PLAN REVIEW COMMENTS FOR DP-03-26-020162

Plan Type:	Development Plan	Apply Date:	03/06/2026
Plan Status:	Active	Plan Address:	21 Maiden Lane BLUFFTON, SC 29910
Case Manager:	Dan Frazier	Plan PIN #:	R610 039 00A 0042 0000
Plan Description:	A request by Sturre Engineering, on behalf of property owner Hinton Vacation Properties for review of a Preliminary Development Plan application. The project consists of nine (9) single-family residential lots with common open area and associated infrastructure. The properties are zoned Neighborhood General - Historic District (NG-HD) and consist of 3.58 acres identified by tax map numbers R610 039 00A 0042 0000 and R610 039 00A 042A 0000 located south of Bruin Road west of Pritchard Street STATUS: This item will be heard at the April 15, 2026 Development Review Committee meeting.

MAIDEN LANE DEVELOPMENT

DRAWING TITLE
SITE PLAN

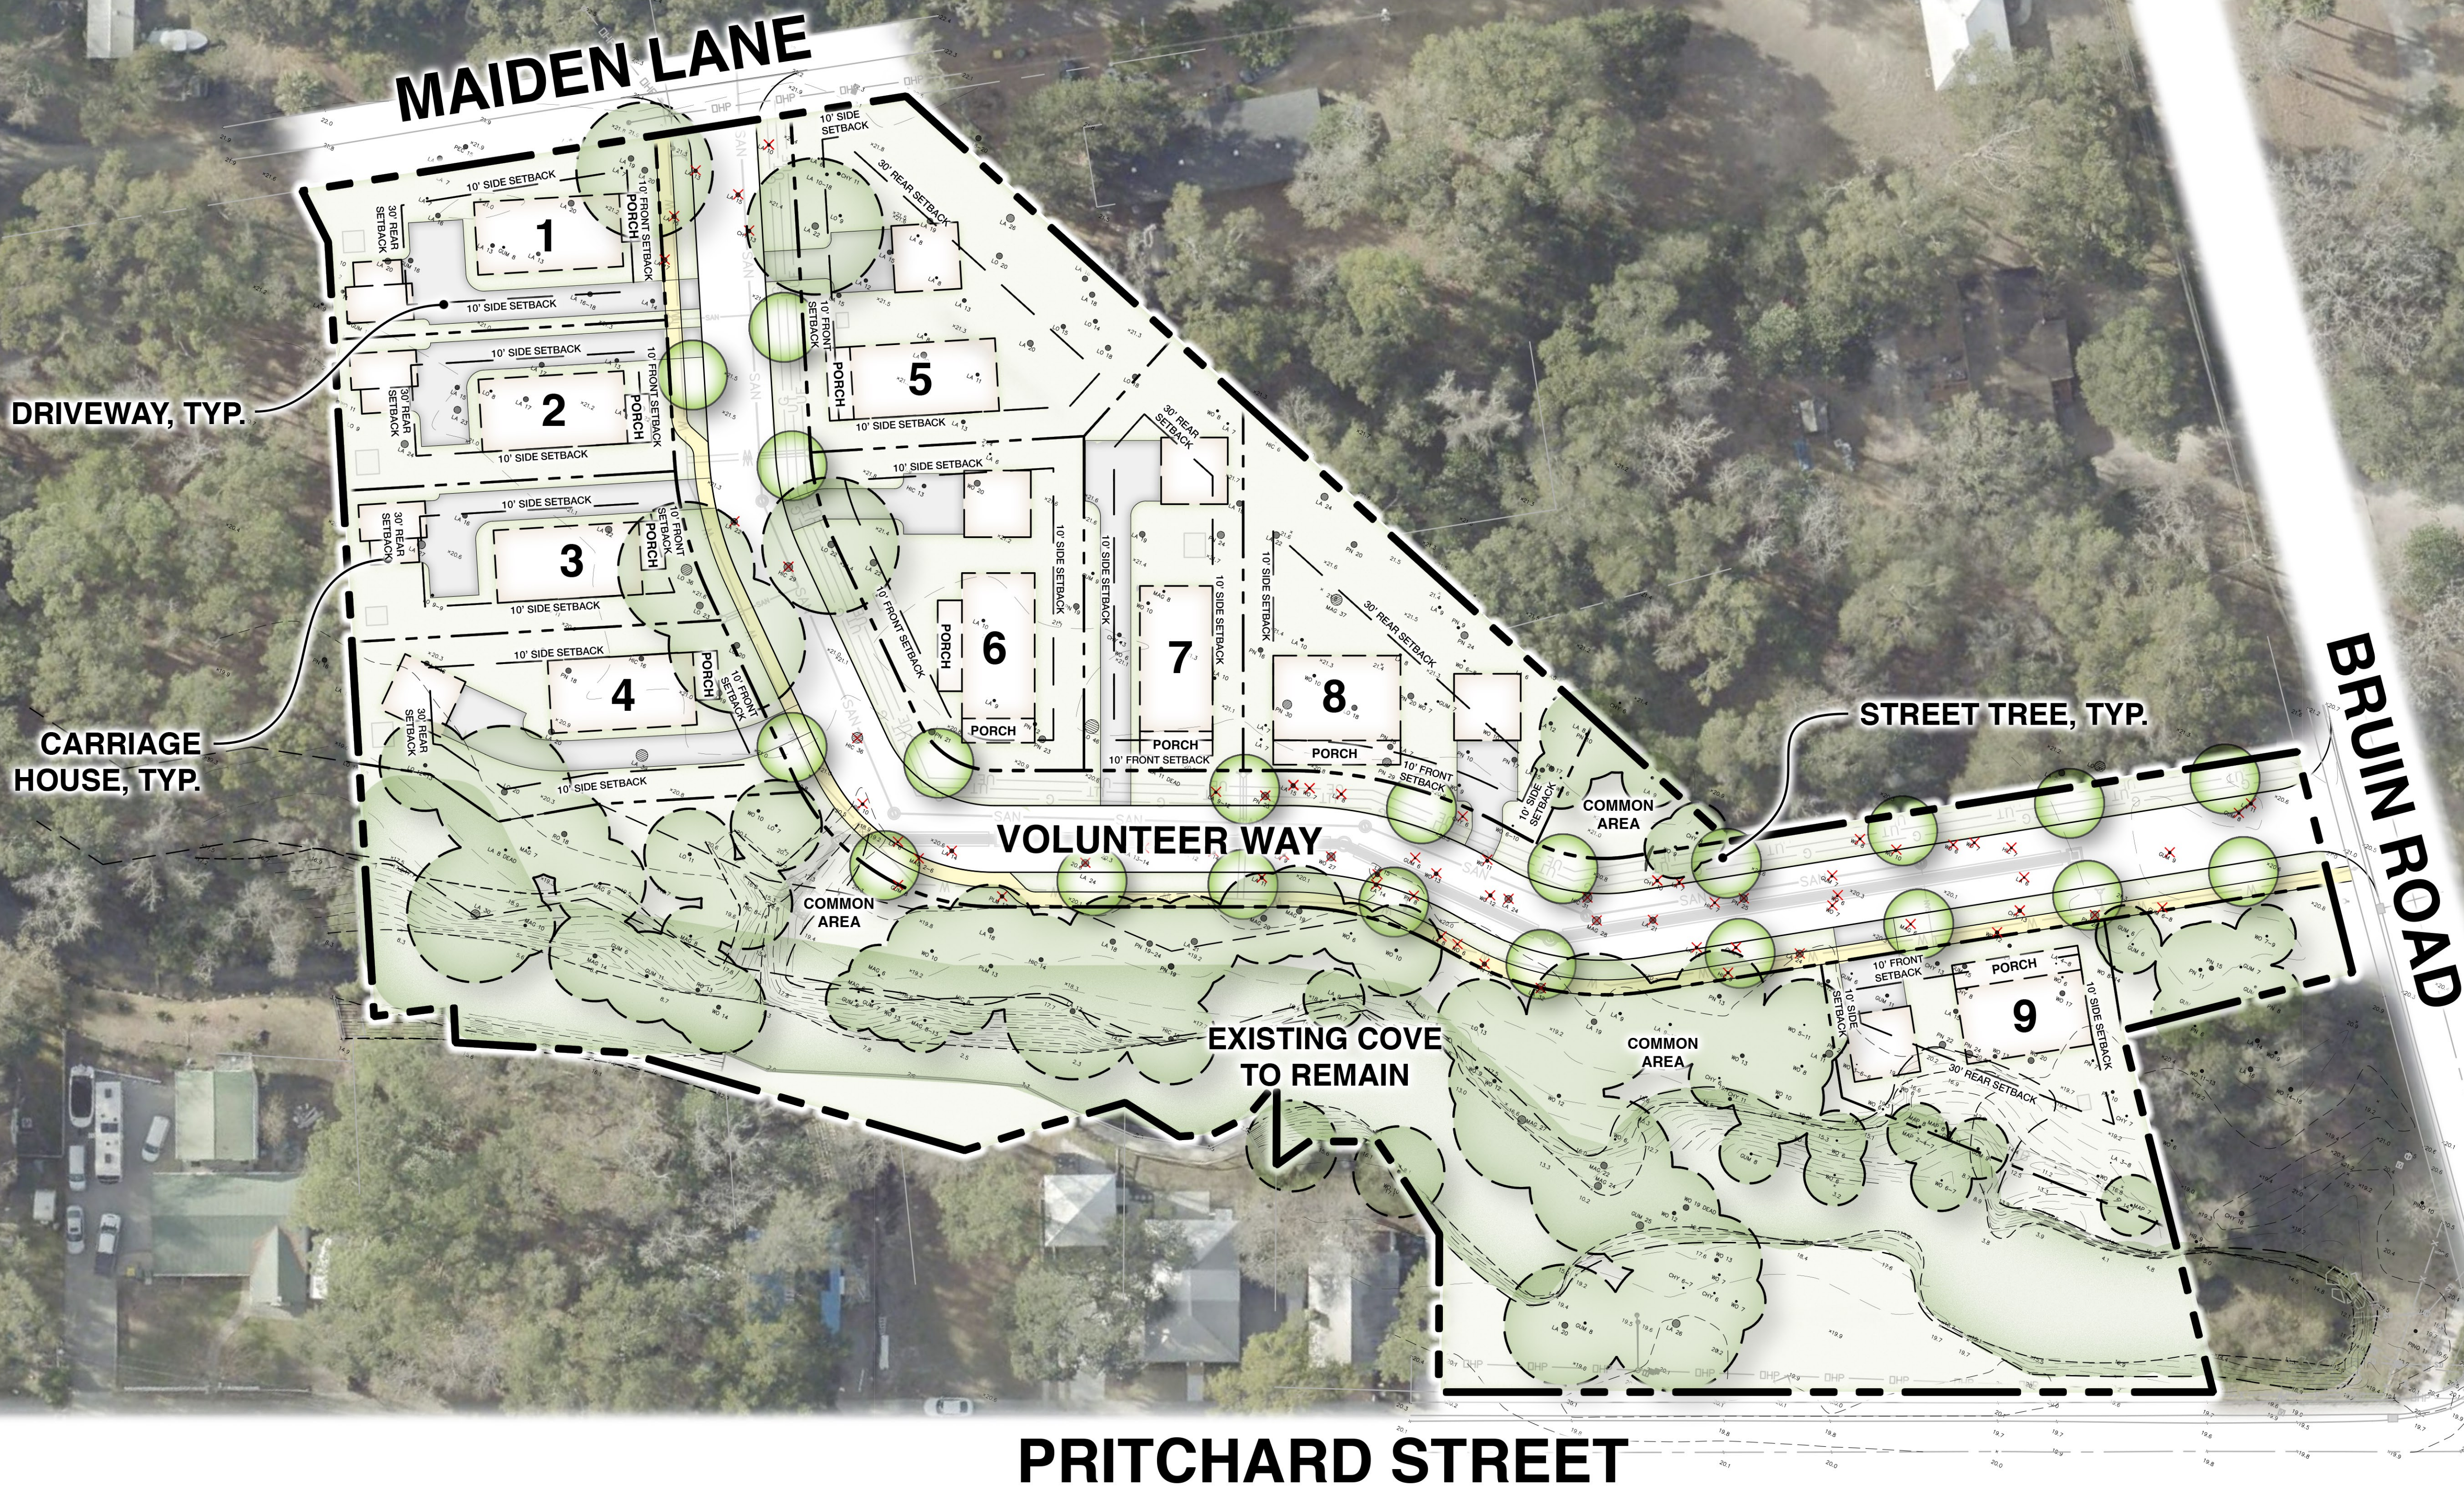
1. Remove Development Summary Table from the Site Data Sheet.
2. Remove building setbacks from Site Plan Sheet. Setbacks are established based on building type.

3. A New Street Name Application will be required to name the proposed new right-of-way.
4. Carriage houses must be placed behind the primary structure and towards the back of the lot.

DRAWING TITLE
TREE REMOVAL PLAN

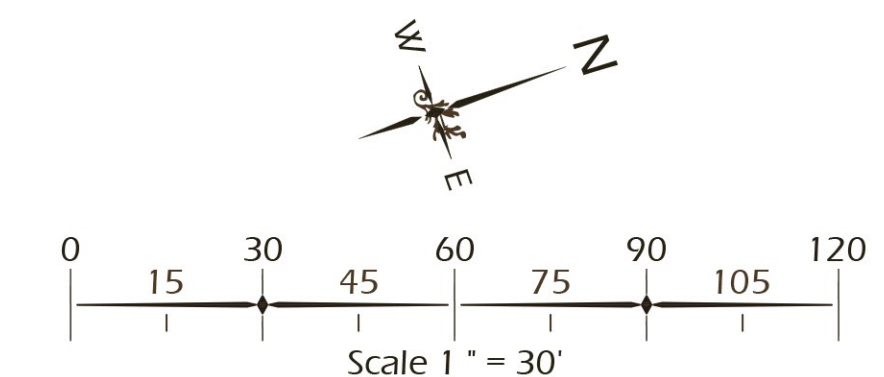
5. Provide a road cross section identifying the above and below grade road features.
6. Consideration shall be given to the existing tree canopy and every reasonable effort made to maximize the preservation of the existing canopy (UDO 5.3.3.C). It appears that by adjusting the alignment of the drive and some lot lines additional significant trees can be retained.
